TECHNICAL & SAFETY COMMITTEE

INTERNATIONAL PARACHUTING COMMISSION (FAI)

Technical & Safety Information Notice No.	**04/2009** **W.N. 25**
Date of Issue	**21 June 2009**
Subject Matter and Applicability	**Infinity Parachute Harness/Container System** **Infinity Owner's Manual Supplement – Location of AAD Cutter**

Infinity Owner's Manual Supplement

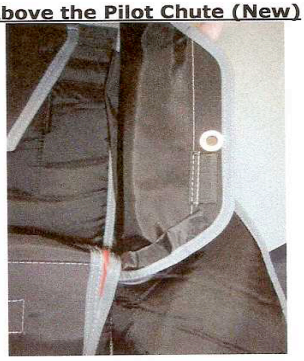
2. To improve the function and effectiveness of an AAD triggered reserve deployment, we have moved the location of the AAD cutter. Note that it was previously located on flap #1 below the pilot chute; we have moved it to flap number 2, above the pilot chute. To protect the cutter and reduce visibility, we have begun installing reserve pilot chutes with recessed caps. As always, there is no specific pilot chute orientation, it will function as designed, in any rotation around the closing loop axis. Pilot chutes with recessed caps may be used with cutters located below the pilot chute.

Below the Pilot Chute (Old)

Above the Pilot Chute (New)

It is not mandatory to have your AAD cutter located above the pilot chute. Should you have an Infinity with the cutter below the pilot chute, and desire to have it fitted above the pilot chute, please contact us and we will do our best to schedule a retro fit in a timely manner.
